MANDATORY SERVICE BULLETIN

MSB 42-095

MSB 42NG-026

Replacement of MLG damper nut.

Drawing Number: **D60-3277-10-00_01**

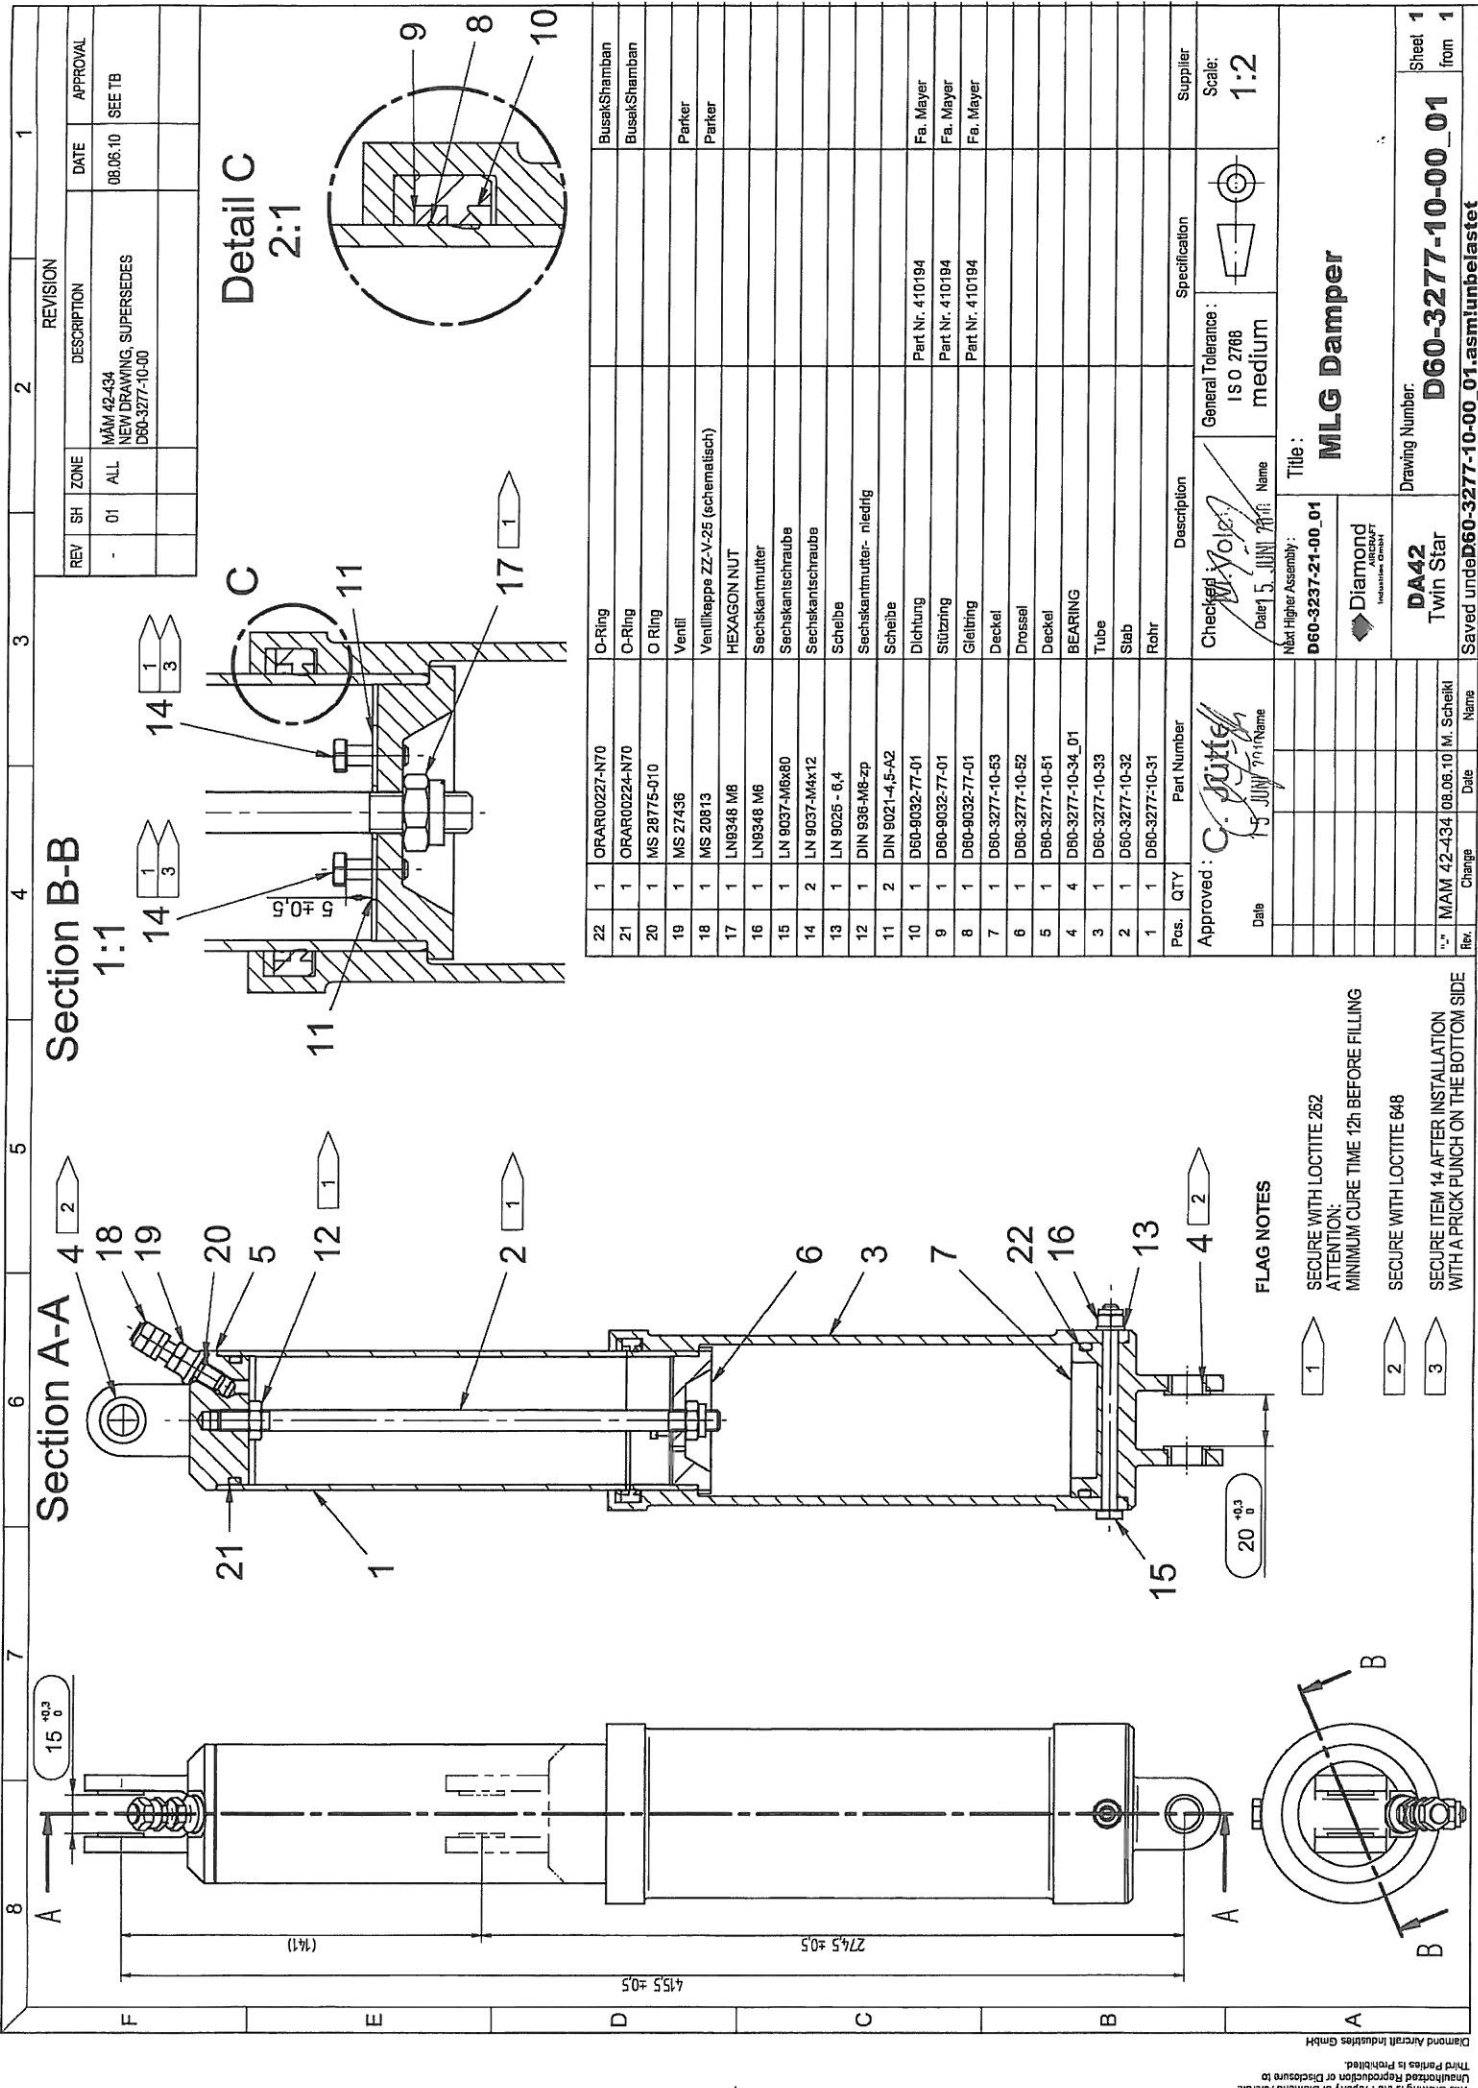
6	Remove the nut on the piston end plate.
7	<p>Install nut LN 9348-08 on the piston end plate. Secure the connection with Loctite 262 i.a.w. drawing D60-3277-10-00_01.</p>  <p style="text-align: center;">Picture 2</p>
8	Allow Loctite to cure before filling (Minimum cure time 12 hours).
9	Install the bottom cap with the bolt, washer and nut.
10	Remove the spacer from piston tube.
11	Install the charging valve with a new O-Ring MS 28775-010.
12	<p>Adjust the direction of the piston tube to the cylinder tube acc. to picture 3.</p> <p>Note: The charging valve must be aligned with the nut from the bolt holding the bottom cap.</p>  <p style="text-align: center;">Picture 3</p>
13	Fill and charge the Damper acc. to AMM Section 32-10.
14	Install the Damper to the MLG acc. to AMM Section 32-10.

- FLAG NOTES**
- 1 SECURE WITH LOCTITE 262
ATTENTION:
MINIMUM CURE TIME 12h BEFORE FILLING
 - 2 SECURE WITH LOCTITE 648
 - 3 SECURE ITEM 14 AFTER INSTALLATION
WITH A PRICK PUNCH ON THE BOTTOM SIDE
